## Application for Licence

<b>Licence Number</b>	L9415/2023/1
<b>Applicant</b>	Pilbara Energy (Generation) Pty Ltd
<b>ACN</b>	631 303 305
<b>File number</b>	DER2023/000452
<b>Premises</b>	PEG Power Station Solomon Iron Ore Mine  Legal description Part of Mining Tenement L47/901 As defined by the coordinates in Schedule 2 of the issued licence
<b>Date of report</b>	21 January 2025
<b>Decision</b>	Licence granted

Figure 1: Contour plot of predicted maximum 1-hr NO<sub>2</sub> concentrations from Scenario 7

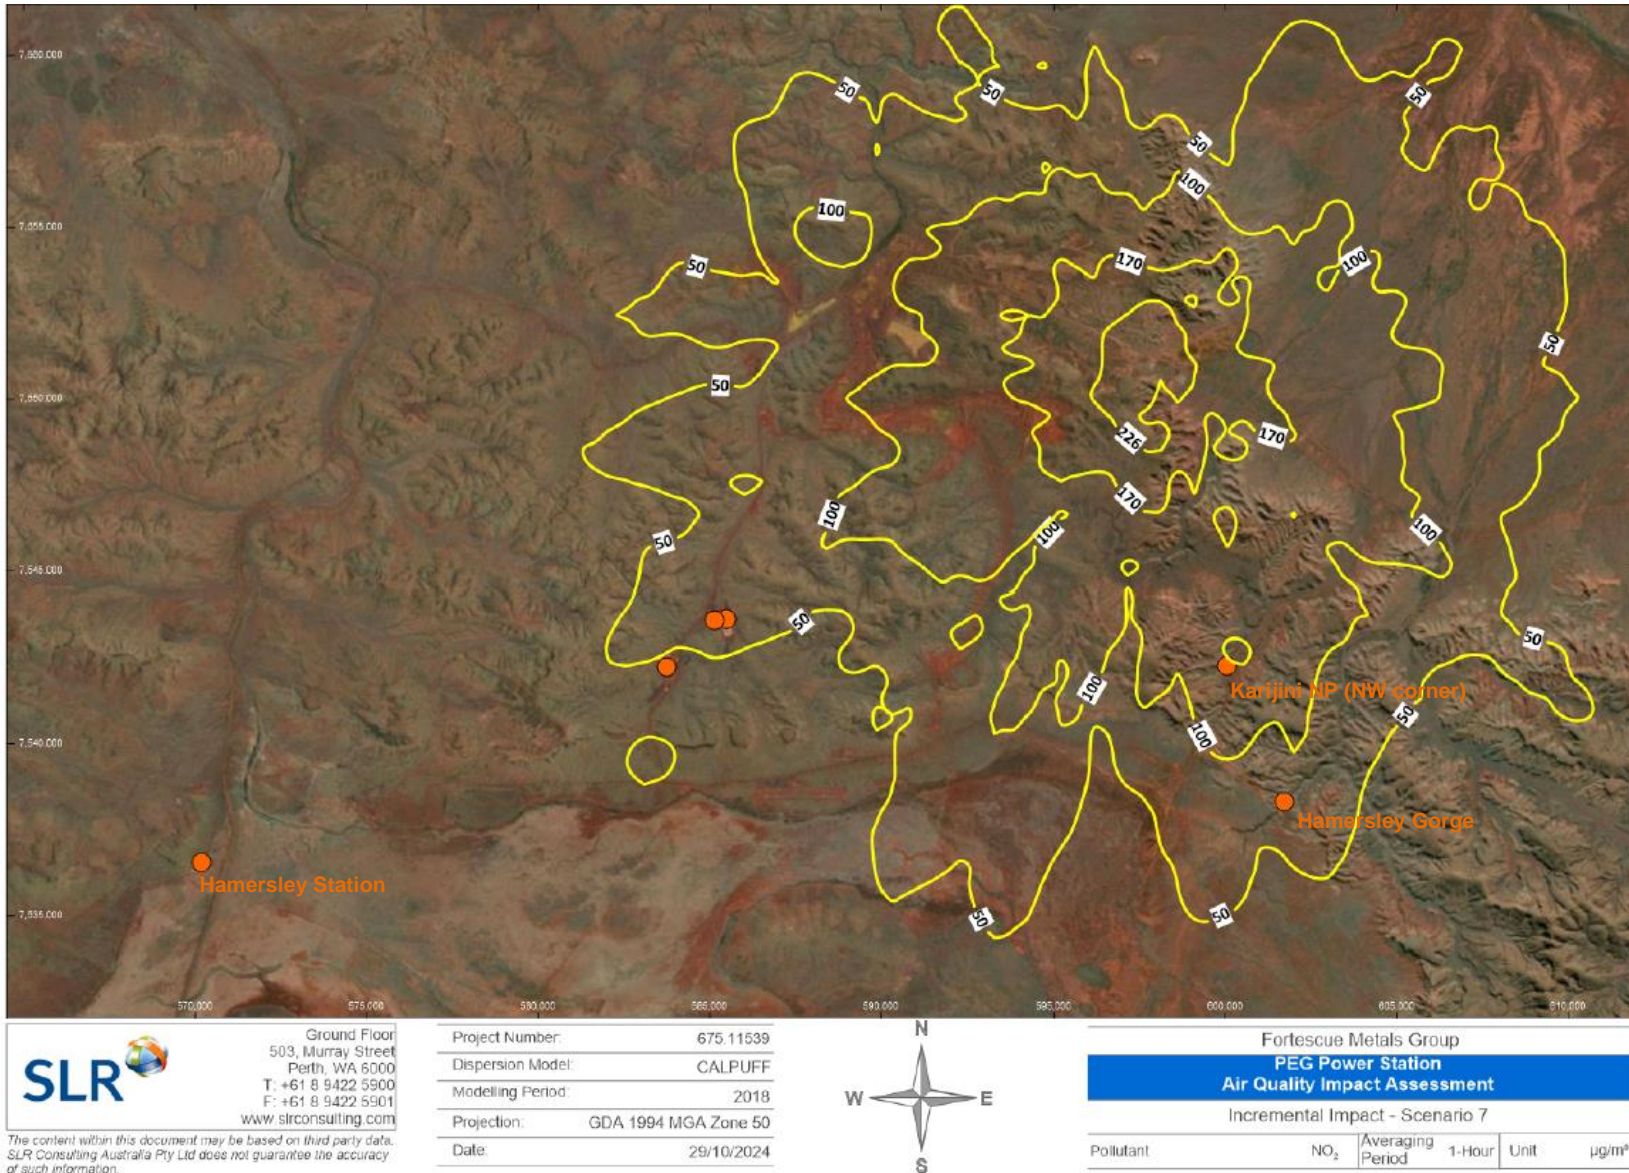
The 2020 AQIA developed for the works approval included contour plots for each scenario listed in Table 1. The contour plot for scenario seven can be seen in Figure 1 illustrating predicted GLCs in a regional context for a more typical operating scenario. Note that the contour plot is for the original AQIA developed in 2020 and not the revised 2023 AQIA and depicts marginally different GLCs (higher) to those presented in Table 1 as the modelling was more conservative.
